Application Note 51625
(Revision -, 4/2020)
Original Instructions

RVP-200

Preserving Factory Calibration during Installation

Figure 3. Partially transparent view of updated design showing set screws that provide greater alignment stability

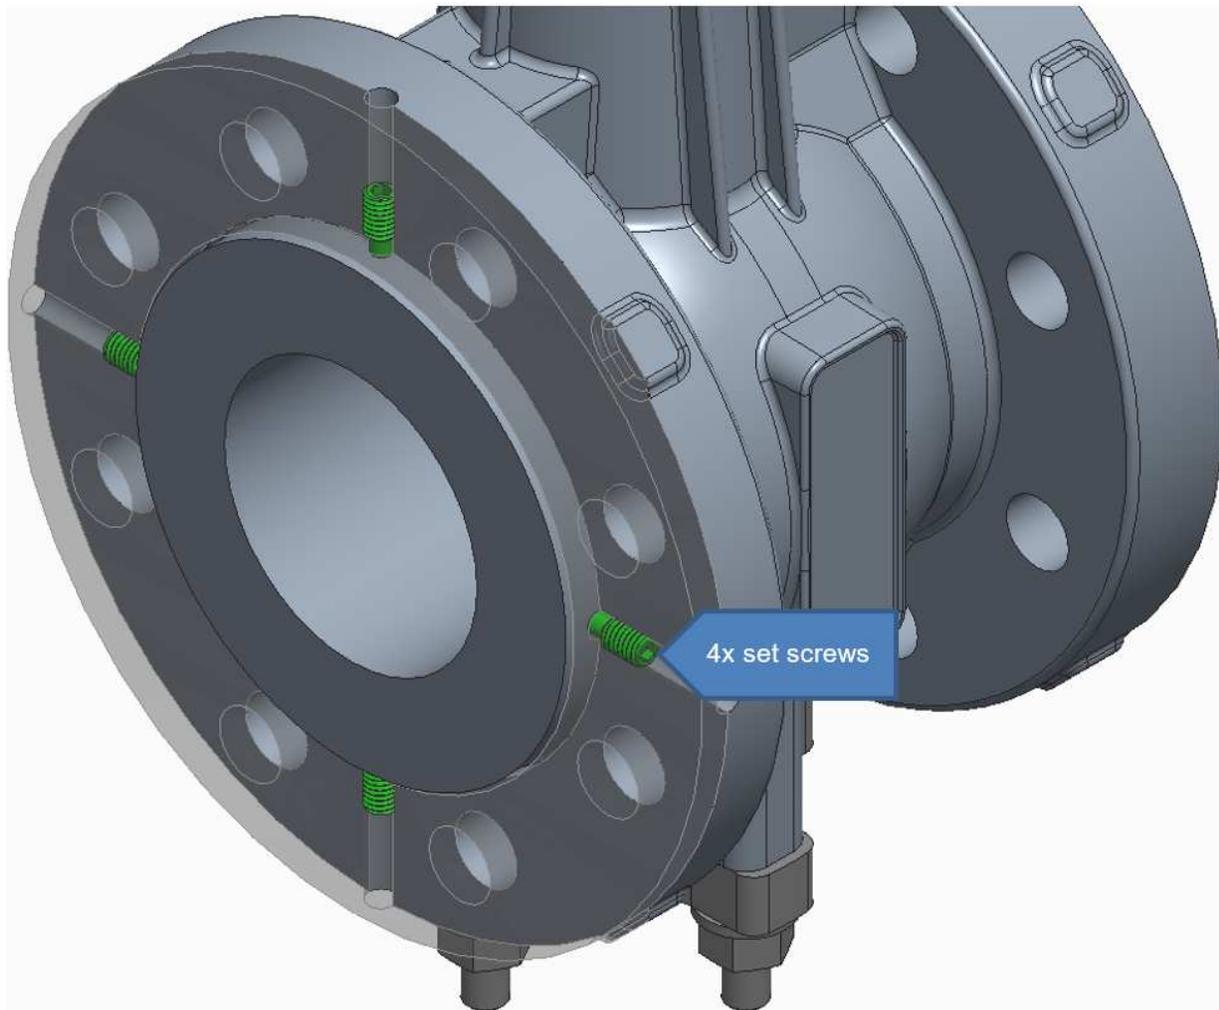
The updated design adds four (4) set screws around the tube that restrain the position of the sleeve as illustrated in Figure 3. Do not attempt to adjust these factory calibrated screws. Adjusting the screws reduces their effectiveness and can damage the valve trim.

Figure 4. Six-inch valve with additional axial retaining bolts

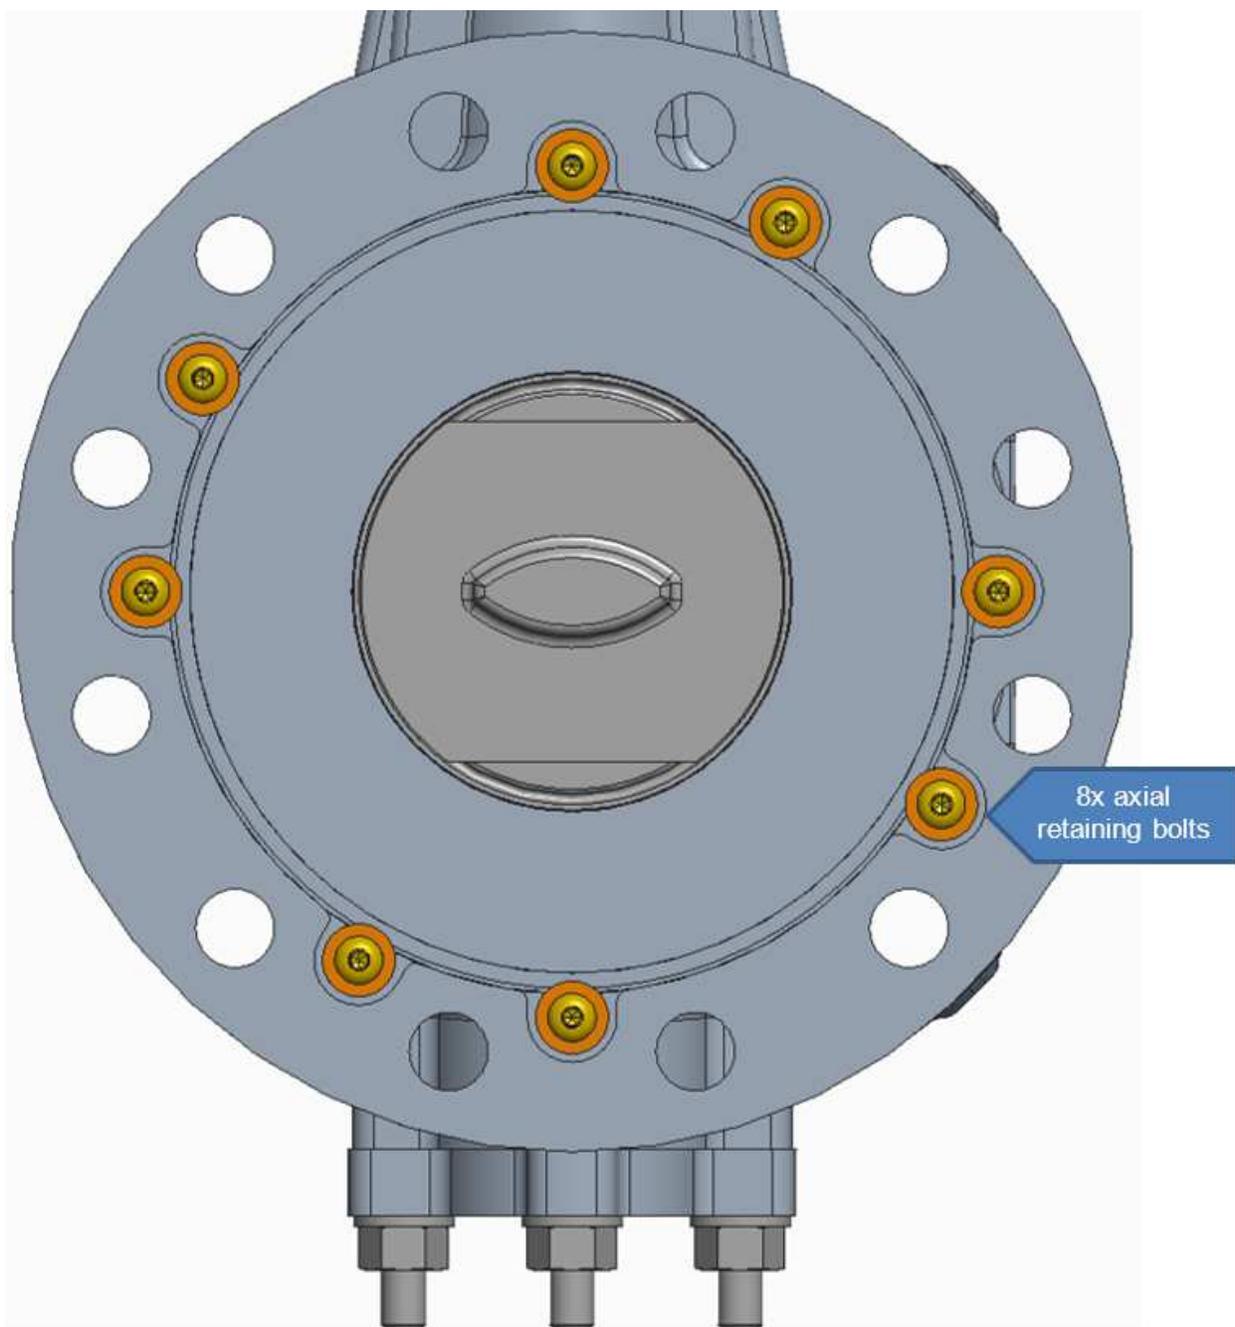
Six-inch flange size valves also have an additional retaining feature added. Previous designs used four bolts mounted in the axial direction to retain the tube during installation. The updated design adds an additional four bolts (Figure 4) to further improve retention forces.
